AMENDMENT OF SOLICITATION/MODIFICATION OF CONTRACT				1. CONTRACT ID CODE J		PAGE OF PAGES 1 13	
2. AMENDMENT/MODIFICATION NO. 0002		3. EFFECTIVE DATE 13-Jun-2005		4. REQUISITION/PURCHASE REQ. NO. W16ROE-5090-1738		5. PROJECT NO.(If applicable)

14. DESCRIPTION OF AMENDMENT/MODIFICATION (Organized by UCF section headings, including solicitation/contract subject matter where feasible.) The purpose of this amendment is to include the attached changes/clarifications to the original solicitation. Bid opening date originally scheduled for 14 June 2005 at 1:30 P.M. is hereby changed to 21 June 2005 at 3:00 P.M., local time. All other terms and conditions of the solicitation remain unchanged.							
Except as provided herein, all terms and conditions of the document referenced in Item 9A or 10A, as heretofore changed, remains unchanged and in full force and effect.							
15A. NAME AND TITLE OF SIGNER (Type or print)				16A. NAME AND TITLE OF CONTRACTING OFFICER (Type or print)			
				TEL: _____ EMAIL: _____			
15B. CONTRACTOR/OFFEROR _____ (Signature of person authorized to sign)		15C. DATE SIGNED		16B. UNITED STATES OF AMERICA BY _____ (Signature of Contracting Officer)		16C. DATE SIGNE

THE PENINSULA AT BAYONNE HARBOR
LOT 1, BLOCK 404
AMBROSE CHANNEL MATERIAL CDF
SOIL EROSION & SEDIMENT CONTROL PLAN

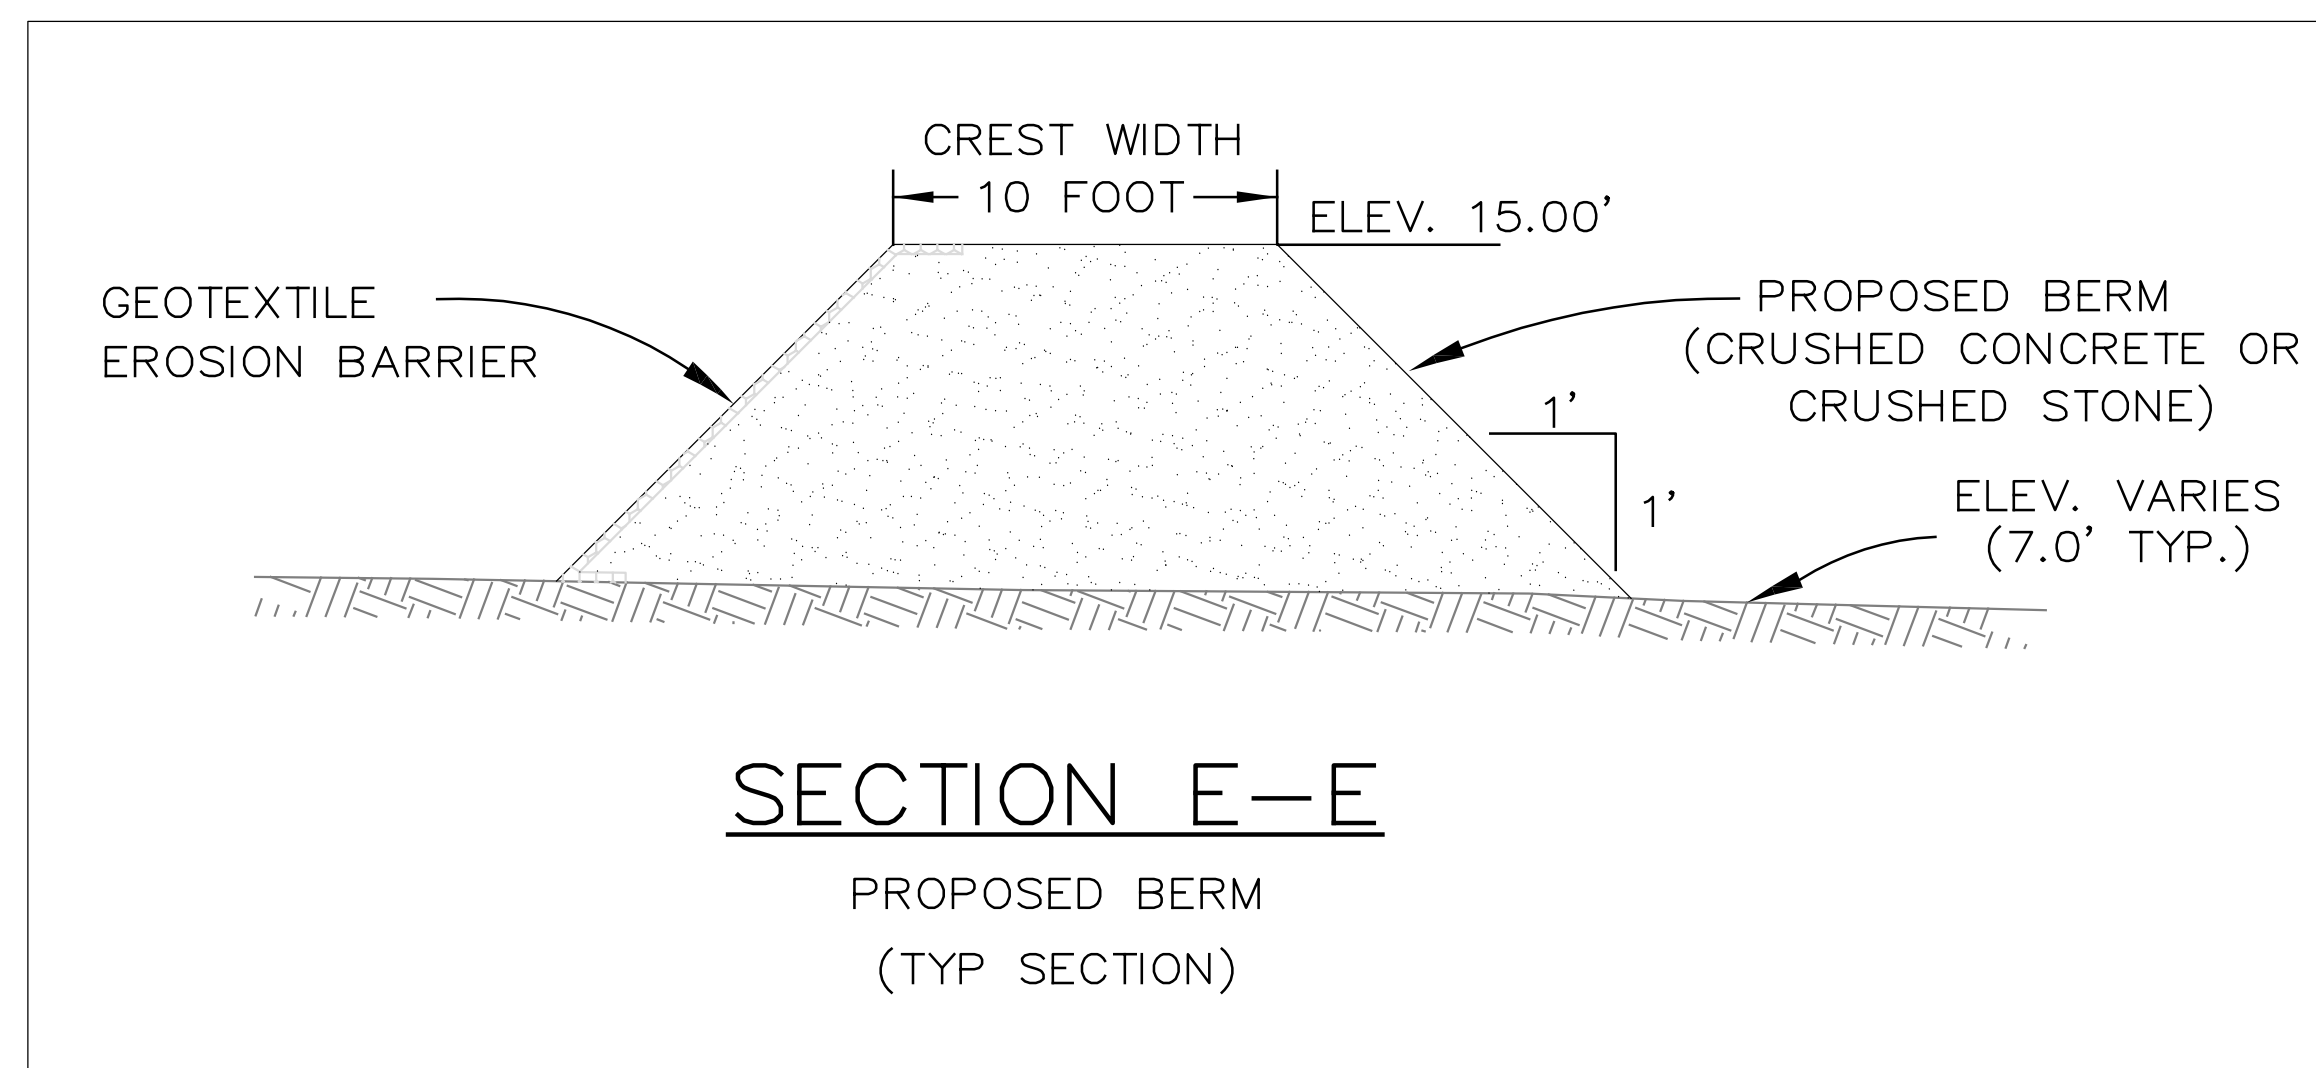
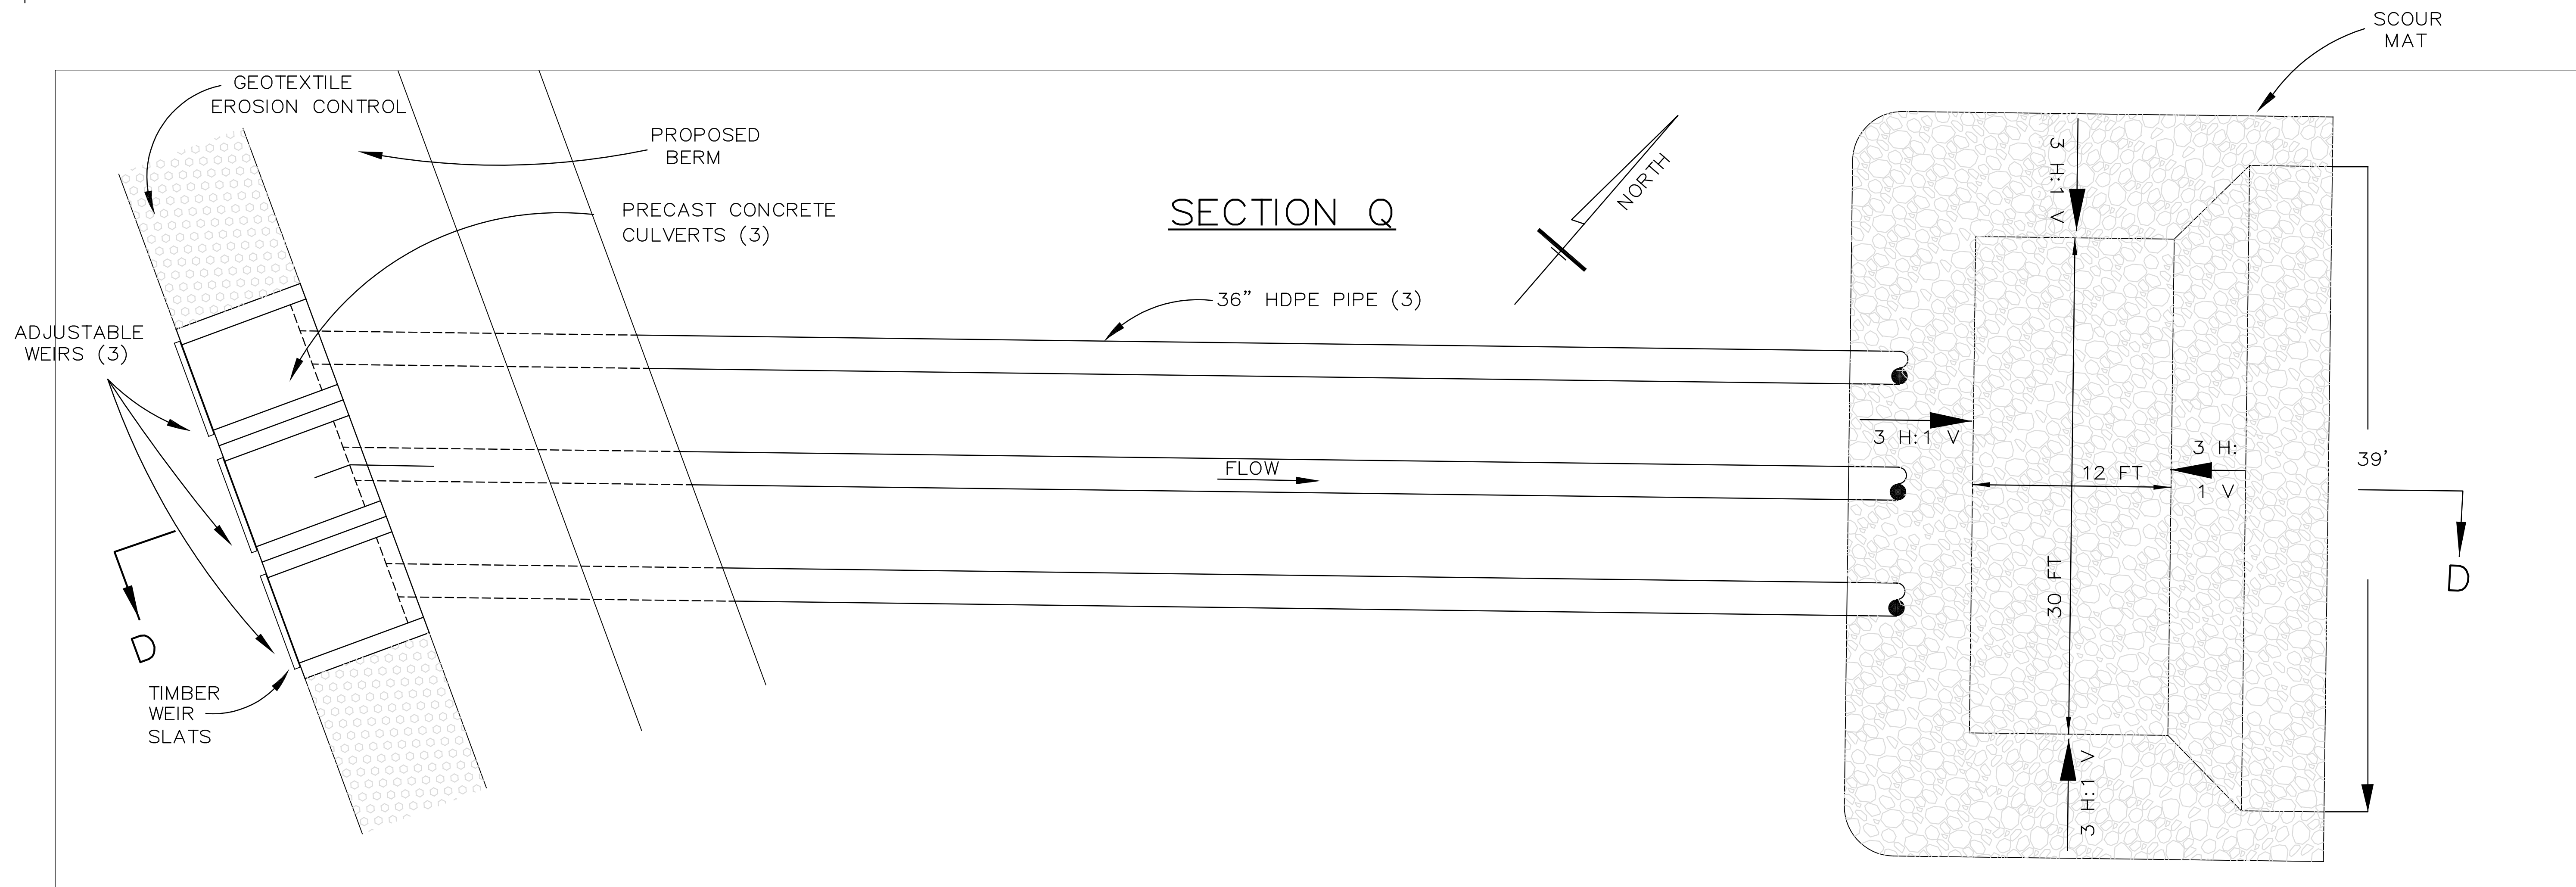
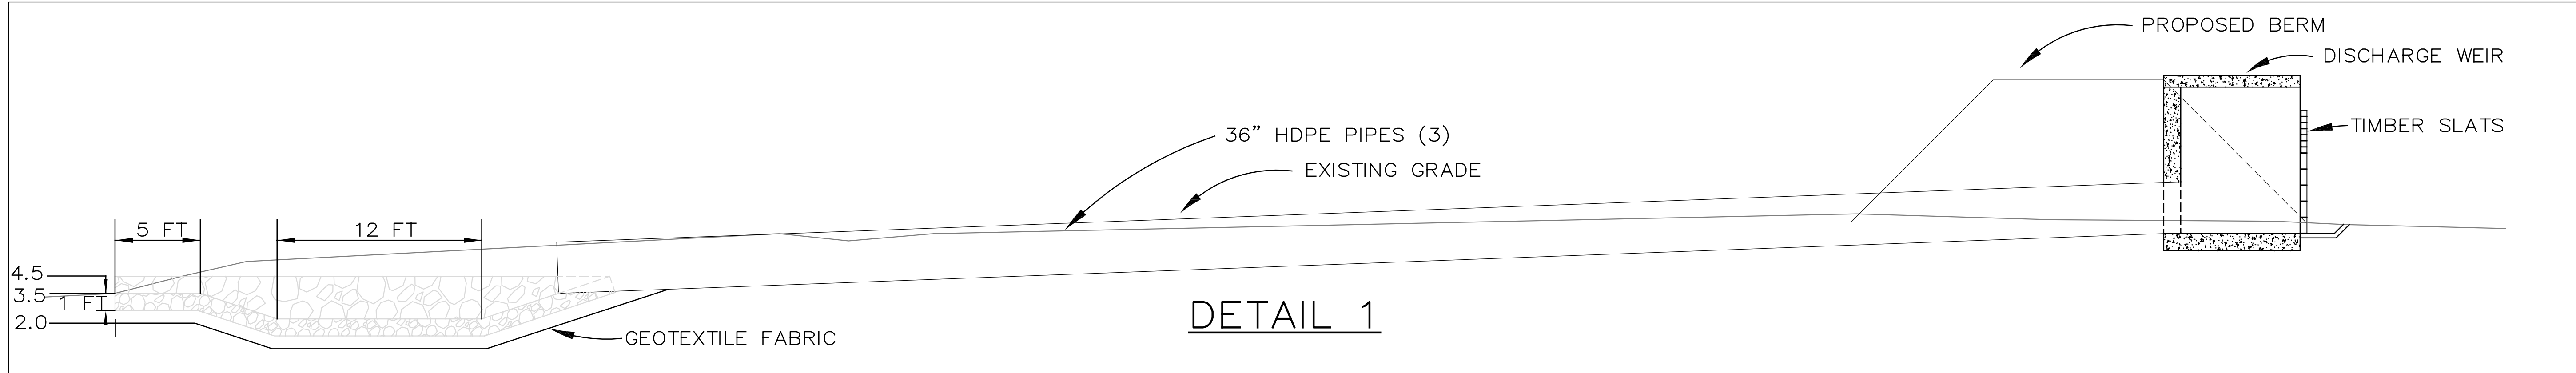
5/8/05	RELOCATED DISCHARGE WEIR	NPJ		
4/20/05	ADDED M.H.W.L. & S.H.W.L.	JAB	ST	NJ
4/19/05	REVISED PER H.E.P.S.C.D LETTER DATED 4/12/05	JAB	ST	NJ
NO.	DATE	REVISION	DRAWN	CHK'D
